Technical Service Bulletin

SUBJECT:			No: TSB-13-17-002
REVISED ACC/FCM ECU DIAGNOSIS (INCLUDING DTC C1753) – SERVICE MANUAL REVISION			DATE: December, 2013
			MODEL: 2014 Outlander
CIRCULATE TO:	<input type="checkbox"/> GENERAL MANAGER	<input checked="" type="checkbox"/> PARTS MANAGER	<input checked="" type="checkbox"/> TECHNICIAN
<input checked="" type="checkbox"/> SERVICE ADVISOR	<input checked="" type="checkbox"/> SERVICE MANAGER	<input type="checkbox"/> WARRANTY PROCESSOR	<input type="checkbox"/> SALES MANAGER

This TSB adds failsafe functions related to the ACC/FCM ECU to the service manual and revises the diagnostic steps for DTC C1753 – ACC/FCM radar blockage detected.

DISPLAY ITEM LIST

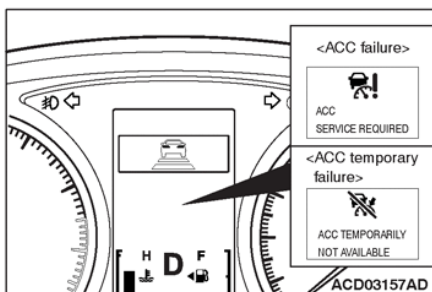
<Added>

Insert the attached sheet 3 (2/3)
